Bid Bulletin #01

PROJECT: Skinner Early Childhood Center
Bid Package #2
Omaha, NE

ADDENDUM B

Structural Package
Skinner Early Childhood Center
Omaha, Nebraska
RDG Project No. 2014.128.00, File 35.1

8 COOLING TOWER ENCLOSURE FOOTING SECTION
S03.07 SCALE: 3/4" = 1'-0"

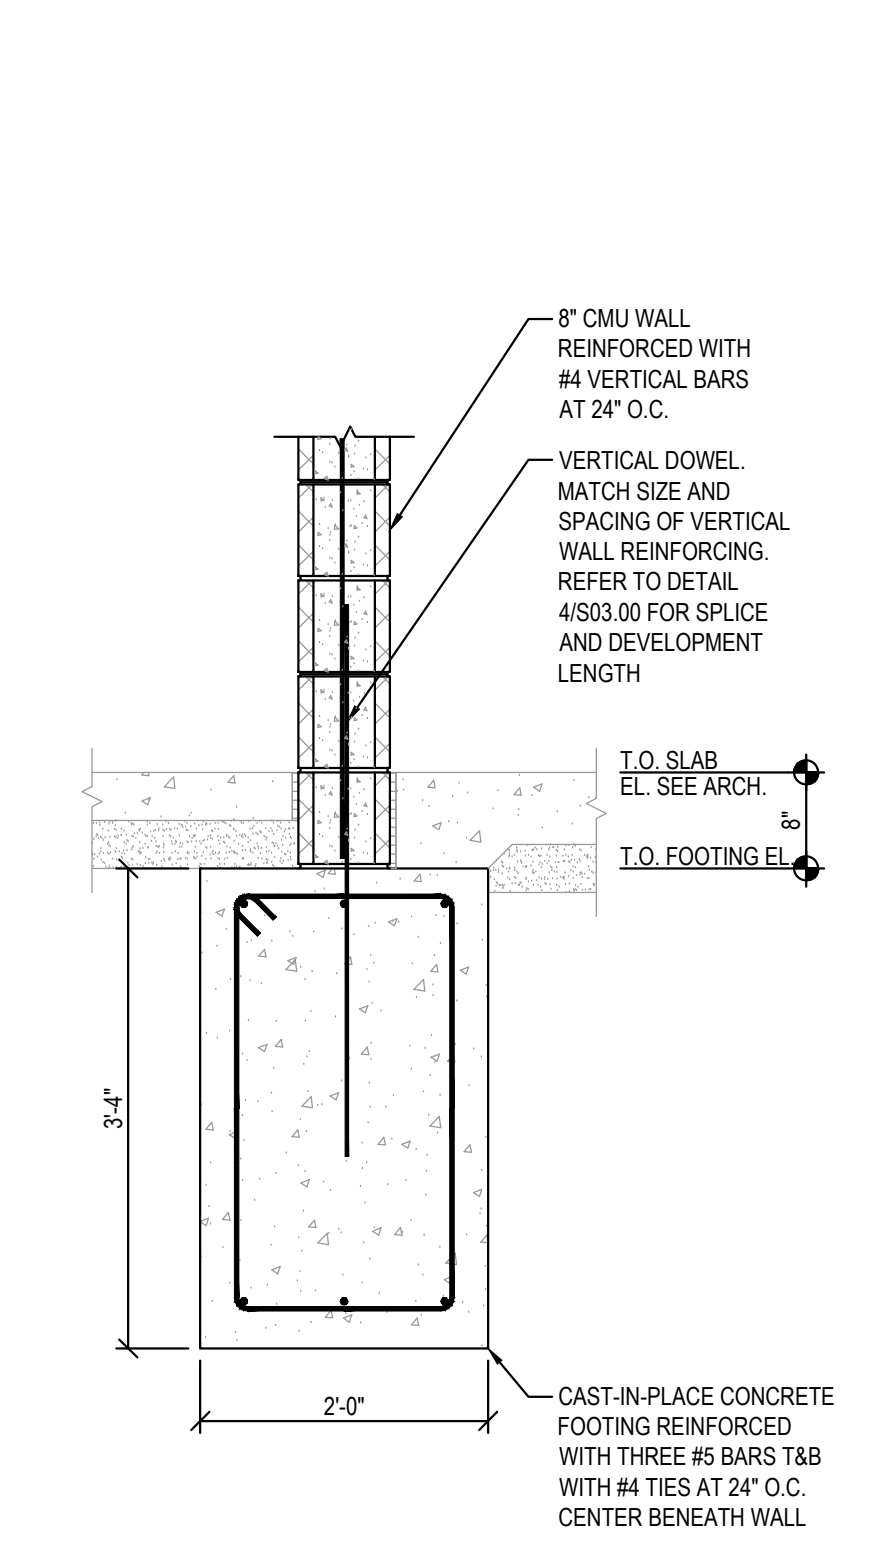
B. Section 8 – COOLING TOWER ENCLOSURE FOOTING SECTION: Revise track-to-stem wall connection as follows.

1 1/2" DEEP CONT. TRACK MATCHING STUD WIDTH AND GAUGE WITH TWO 1/4" TAPCON ANCHORS WITH 1 1/4" EMBEDMENT AT 32" O.C. AND 4" GAGE.
